Office Action Summary	Application No. 10/711,842	Applicant(s) REITER, MARKUS	
	Examiner THOMAS W. IRVIN	Art Unit 3683

DETAILED ACTION

Claims 1-9, 12, 15, and 16 are rejected under 35 U.S.C. 102(b) as being anticipated by Kamada (6,340,338).

FIG. 12

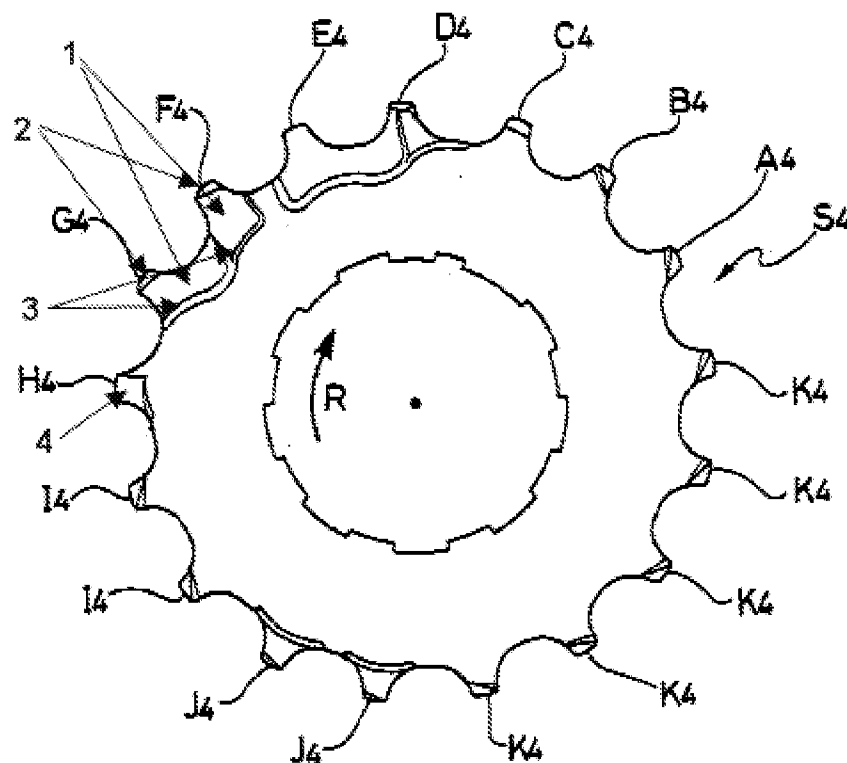
In Re claim 1, with reference to Fig. 3, 13, and 12 (above), '338 discloses a chainwheel assembly including a plurality of chainwheels (s1-s7) engageable with a

chain (23) having successive alternating pairs of inner link plates and outer link plates connected by pins, the pins surrounded by rollers, the chainwheel assembly comprising: at least one smaller chainwheel (s3) having a plurality of teeth spaced about its circumference; and at least one larger chainwheel (s4) having a greater number of teeth spaced about its circumference than the smaller chainwheel, the larger chainwheel and the smaller chainwheel oriented relative to each other such that a distance between a center of the chain roller positioned between a pair of adjacent teeth on the larger chainwheel and the center of the chain roller between a pair adjacent teeth on the smaller chainwheel is substantially an integer multiple of the chain pitch, at least a first tooth (f4) of the pair of adjacent teeth (F4,G4) on the larger chainwheel includes a lateral recess (1) disposed on a front face of the larger chainwheel facing the smaller chainwheel to allow the chain to move from the smaller chainwheel towards the larger chainwheel, at least a second tooth (G4) of the pair of adjacent teeth disposed adjacent to the first tooth opposite the drive rotation direction having a configuration to prevent the second tooth from capturing the chain.

In Re claim 2, '338 further discloses that the recess is configured to include a run-on ramp (3) for lifting the chain, the run-on ramp extending to a tooth root of the second tooth.

In Re claim 5, '338 further discloses that the larger sprocket includes a third tooth (H4) disposed adjacent the second tooth opposite the drive rotation direction includes a run-out chamfer (4) disposed on the front face of the larger chainwheel, the run-out chamfer extending obliquely backward opposite to the drive rotation direction to provide a shifting lane for the link plate.

In Re claim 8, '338 further discloses that the second tooth (G4) includes a deflection chamfer (2) directed toward the smaller chainwheel to prevent the second tooth from capturing the chain.
